Re: Uranerz Energy Corporation Nichols Ranch ISR Project Source Material License Application Responses to the Wyoming Department of Environmental Quality – Land Quality Division Fourth Consolidated Technical Review.

Uranerz Energy Corporation
Hank and Nichols Ranch ISR Permit Application
TFN 4 2/284
Fourth Consolidated Review Responses
June 24, 2010
Page 1

The following information is the Uranerz (URZ) responses to the 4th Consolidated Technical Review comments provided to Uranerz by the WDEQ-LQD in a letter dated June 3, 2010.

DRAWDOWN IN OBSERVATION WELLS

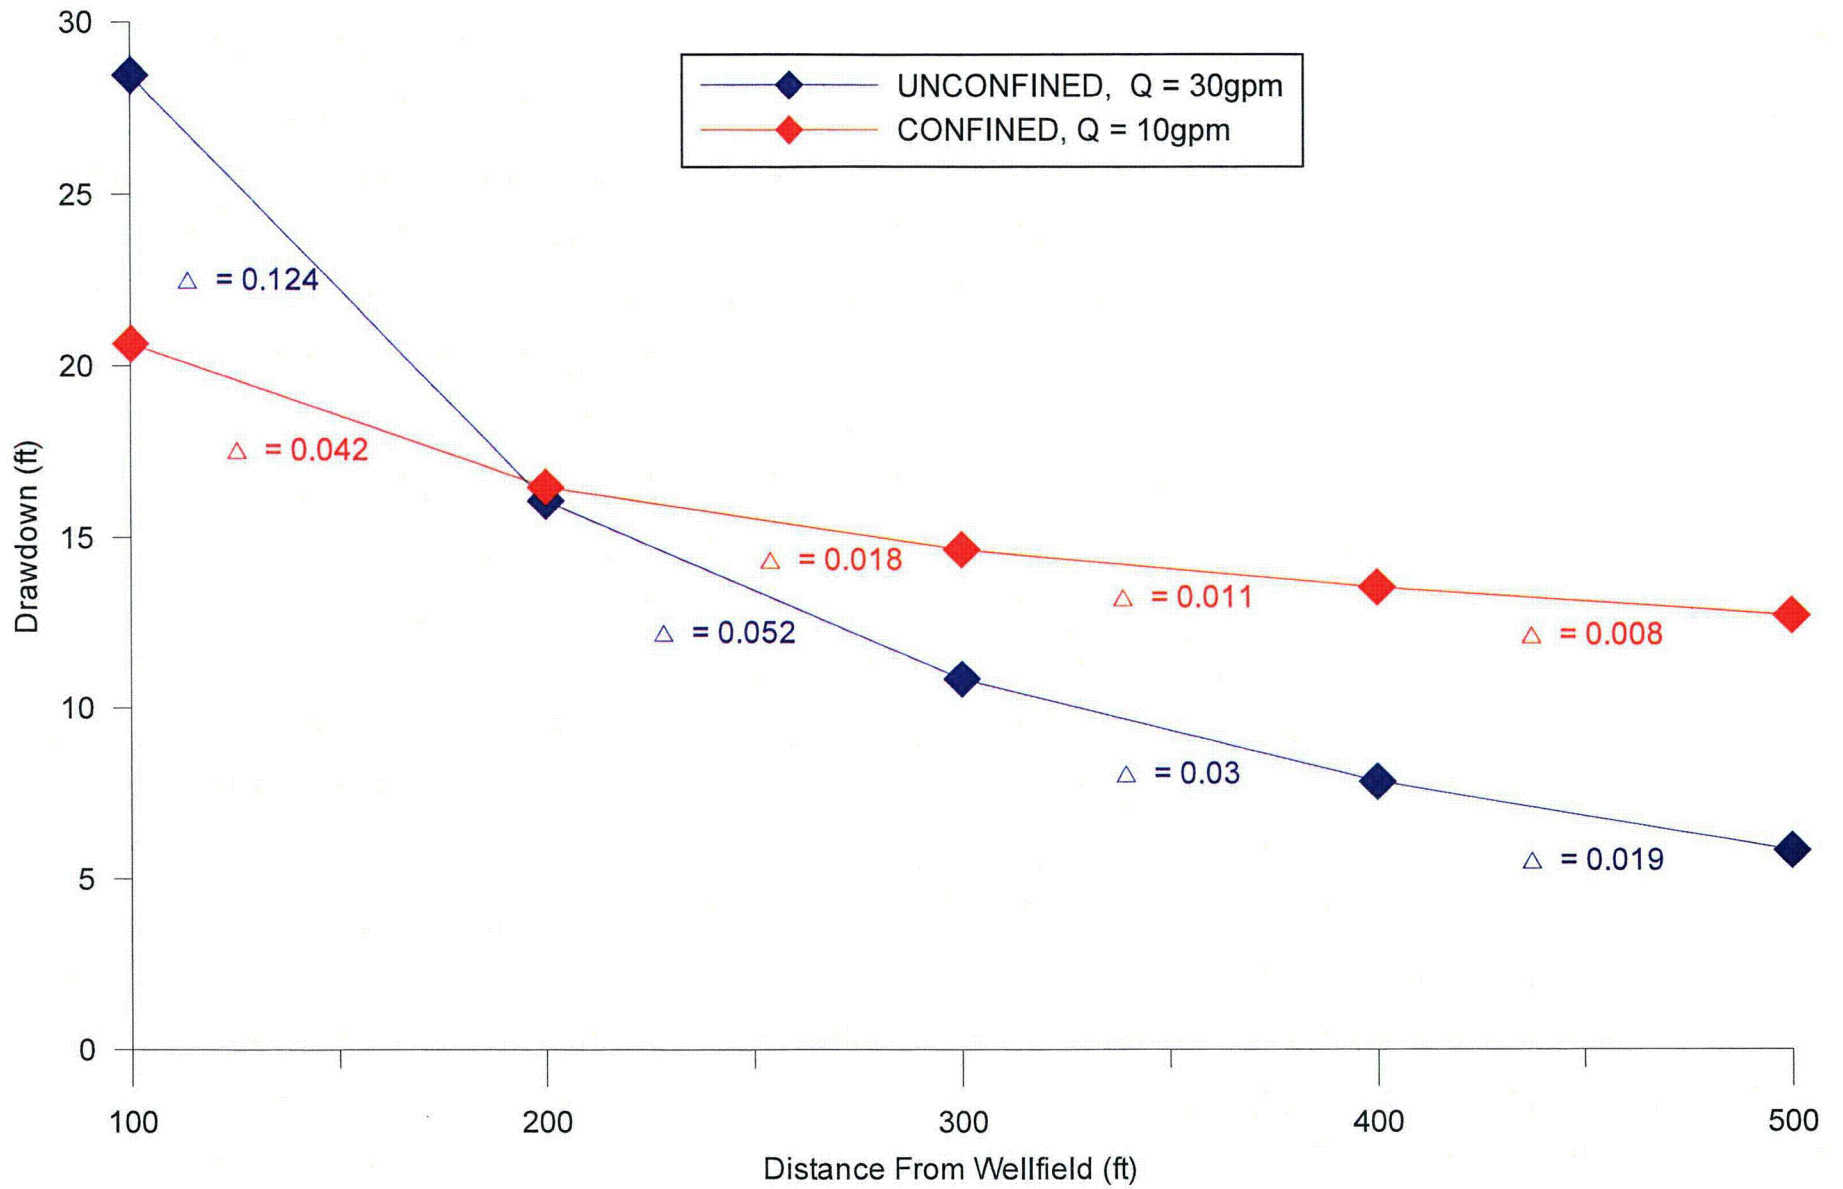
114-M.Mine Plan, Section 3.4, Lixiviant Control: Uranerz response doesn't really address my original comment (i.e., Please elaborate on why Uranerz feels that the 3% bleed at the Hank ranch unit will control the lixiviant in an unconfined aquifer. Please include literature reference or case history, if possible). Uranerz seems to make the argument that control is easier in a confined system than an unconfined system, but then concludes that it's easier in an unconfined system. If

all things consider being comparable, the cone of depression resulting a wellfield in a confined aquifer would be deeper and have much more areal extent than the cone of depression in an unconfined aquifer. Accordingly, it would seem the control of lixiviant at the Hank Site will be harder to maintain control and recover an excursion than at the Nichols site due to the much larger storage value that exists in the unconfined F Sand at the Hank site. Please revise response to address my original comment and provide permit text explaining why a bleed of 3% was modeled. (MT)

The control of solutions at the Hank site will be easier to maintain than at the Nichols site due to a larger anticipated bleed rate necessary to overcome the slower cone of depression development resulting from the much larger storage value that exists in the unconfined F Sand at the Hank site. The piezometric surfaces from the numerical model simulations show that a steep gradient is developed in the unconfined aquifer due to the combination of a larger bleed rate and a large storage value. These results are presented in Figure MPH.1-5 for after one year of operation, Figure MPH.1-10 after 120 days of operation and Figure MPH.1-13 after 30 days of operations. Each of these three piezometric surface maps show that for these varying time periods of pumping a steep piezometric surface has been developed adjacent to the Hank wellfield which will enhance the control of solutions adjacent to this well unit. The much smaller storage value for a confined aquifer allows the water-level heads to change much quicker and, therefore, allows for imbalances to affect reversals adjacent to a wellfield quicker than in the unconfined aquifer condition.

As indicated previously, a larger (3%) bleed rate is anticipated for the Hank Unit to accelerate the development of the cone of depression at the wellfield and to increase the magnitude of the gradient reversal to the wellfield. Since the primary function of the larger bleed rate is to create the necessary gradient reversal in a timely manner, it can be argued that the bleed rate could be reduced to a level which maintains reversal once the cone of depression is established.

The USGS WTAQ program was used to predict the drawdowns from an unconfined and confined wellfield for 3% and 1% bleed rates, respectively. The aquifer property used for this comparison is a uniform transmissivity for both aquifers of 667 gal/day/ft. A specific yield of 0.14 for the unconfined aquifer and a storage coefficient of 1.8E-4 for both the confined and unconfined aquifer were used. A common aquifer thickness

of 90 feet and a completion of 70-80 feet below the top of the aquifer were used. A total time of 365 days was used for these calculations. A reasonable rate for a portion of the wellfield at the 1% bleed rate is 10 gpm. Therefore, for the 3% bleed a comparable stress rate for the unconfined aquifer would be 30 gpm. Drawdowns were calculated for these two aquifer configurations with the WTAQ program for the confined and unconfined conditions at 100, 200, 300, 400 and 500 feet from the edge of the wellfield. The attached figure shows the calculated drawdowns that would result for the confined aquifer in red and the amount of drawdown for the unconfined aquifer in blue. The drawdown depression would be greater for the confined aquifer beyond 200 feet but the change in drawdowns between adjacent points directly affects the gradients and is more important relative to containment. The change in the drawdowns between each 100 feet interval is also presented. A greater change in drawdown will result in a greater change in the reversal gradient; therefore, the unconfined aquifer would have the longest gradient change between the 100 and 200 feet outward distances. The gradient change between the 400 and 500 feet increments for the unconfined aquifer is essentially equal to the gradient change between the 200 and 300 feet increment for the confined aquifer. The gradient changes are significantly steeper in all of the unconfined aquifer increments than the respective confined aquifer increments, generally by factors of 2 to 3. This shows that at the 3% bleed rate, the unconfined aquifer will create steeper gradients adjacent to its wellfield and therefore, should control lixiviant easier than the confined aquifer.

Section 3.4 Lixiviant Control of the Mine Plan was also revised to discuss the use of the 1% and 3% bleed rates. Revised Mine Plan pages MP-17a and MP-17b are enclosed with these responses.
